Agenda Item # 3

BOA-002895-2024

550 and 524 Western Drive

- Use, Front Landscape Area, Frontage Tree, Parking Layout, Bicycle Parking, and Building Wall Variation Variances to amend a previous variance to allow a church with reduced front landscape area, frontage tree plantings within 15-feet of overhead powerlines, parking lot trees planted more than 75-feet apart, no bicycle parking, and no building wall variations in an I-1, Light Industry District.

SITE PLAN

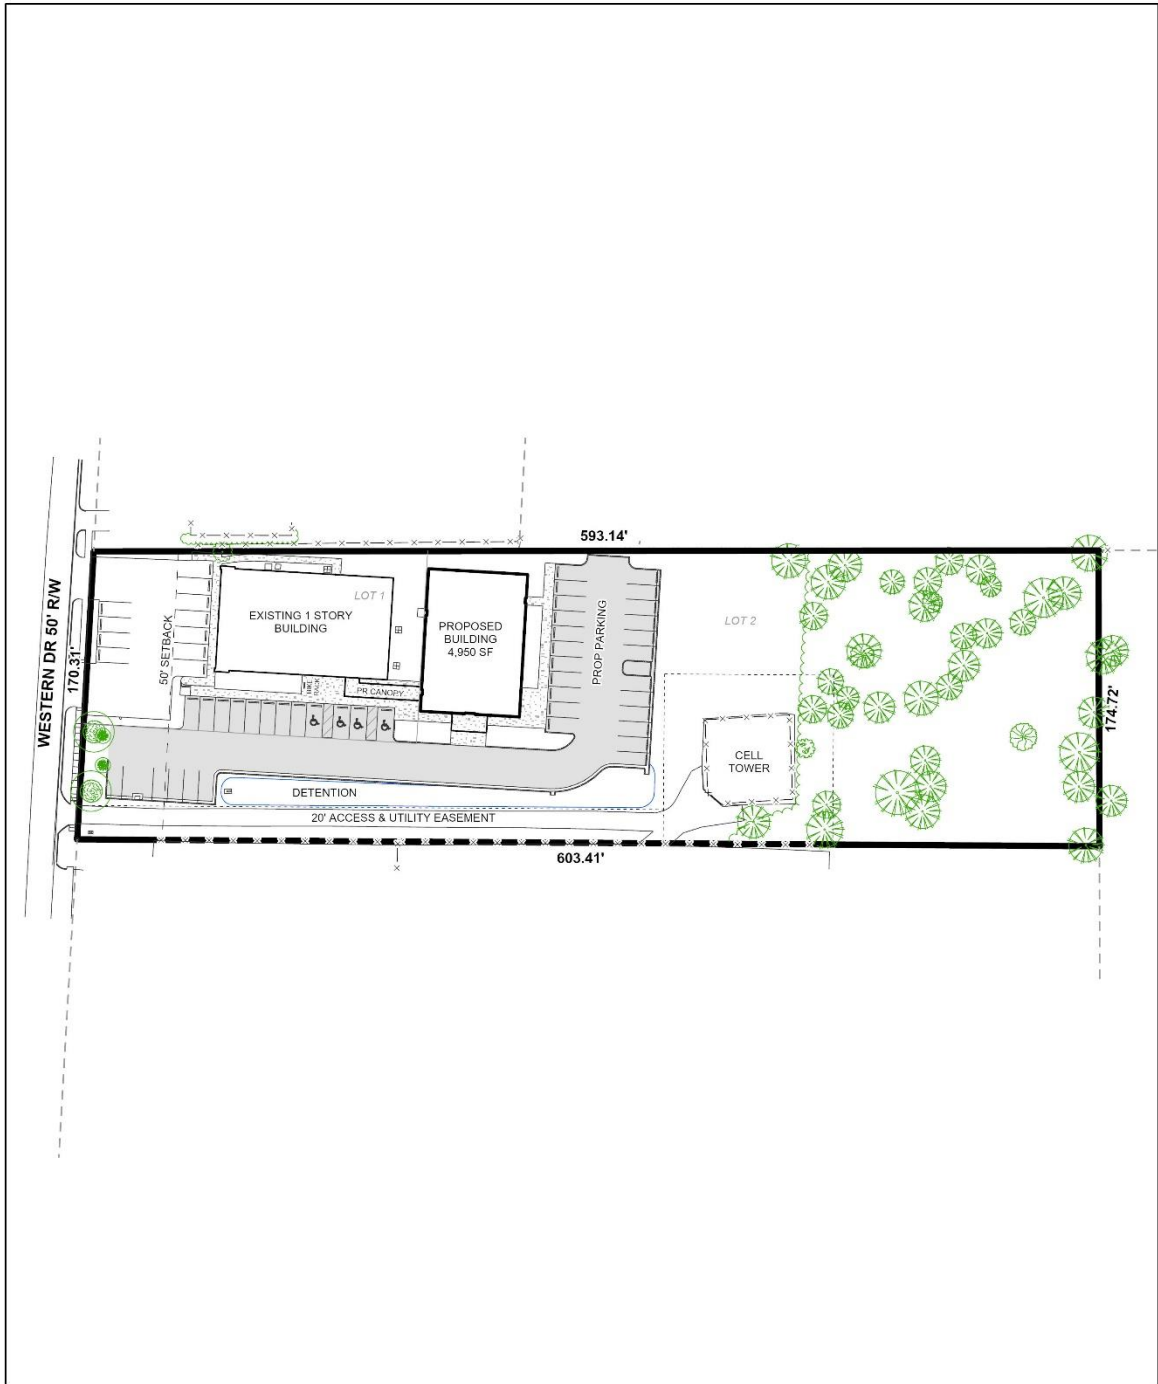
The applicant is proposing to construct a second structure to include a new 160-seat sanctuary, as well as offices and restrooms. The site plan states the size of the new structure will be 4,950± square feet. With the proposed new structure and the existing structure, the site plan states that there will be approximately 5,977 square feet of seating area requiring one (1) parking space per 150 square feet, and 5,090 square feet of other area requiring one (1) parking space per 500 square feet, for a total of 51 parking spaces required; the site plan submitted depicts 53 parking spaces. It should be noted that Article 3, Section 64-3-12.A.5.(d)(3). of the UDC states that for redevelopment of sites greater than one (1) acre, Alternative Parking Surfaces are required for parking spaces in excess of the minimum required spaces. Therefore, as proposed, 2 parking spaces must have an approved Alternative Parking Surface.

The applicant requests that the church be allowed to have a reduced amount of front landscape area due to the existing configuration of the site, which was developed prior to the City of Mobile adopting tree planting and landscape area requirements for non-residential developments. However, as the building footprint is being expanded by more than 50%, the site is required to come into full compliance. It should be noted that some of the existing pavement could be removed in order to comply with this requirement.

Regarding the frontage tree planting requirements, the UDC requires frontage trees to be an overstory species, and prohibits all trees within 15-feet of overhead powerlines. The applicant is proposing to comply with the required number of frontage trees, but is requesting that they be allowed to be crepe myrtles, which are an understory species, and that they be planted less than nine-feet (9') from overhead powerlines. The distance from powerlines requirement was added to the UDC due to issues with tree plantings under/near powerlines associated with the previous zoning requirements.

The UDC requires parking lot trees to be spaced no more than 75-feet on center. It should be noted that the proposed site plan depicts the required minimum amount of parking trees, but there is over 400-feet between trees at the front of the property, and trees at the rear of the site. Bringing the site into compliance with this requirement would result in the site having more parking trees than the minimum required based upon the number of parking spaces. However, the tree spacing requirement is to ensure that trees are planted throughout the parking area, rather than just around the edges of the parking area.

The site plan submitted includes a note stating that bicycle parking in compliance with the requirements of the UDC, but the applicant is requesting relief from this item, stating that the property is zoned industrially, and bicycle use is not anticipated for the individuals participating at various events on the site.

The applicant is also requesting relief from the requirement of the UDC that new buildings have a building wall variation, in the form of either a notch, offset, or projection. The applicant states that as the new building is behind an existing building, and will not front Western Drive, that the required wall variation will have no impact on the appearance of the building from the street.

There is no dumpster depicted on the site plan, nor is there a note stating that curbside pickup will be utilized. If approved, the site plan should be revised to either depict a compliant dumpster, or include a note stating that curbside pickup will be utilized, at the time of permitting.

1. Provision of a photometric site plan compliant with Article 3, Section 64-3-9.C. of the UDC, at the time of permitting;

2. Revision of the site plan to either depict a complaint dumpster, or include a note stating that curbside pickup will be utilized; and
3. Full compliance with all other municipal codes and ordinances.
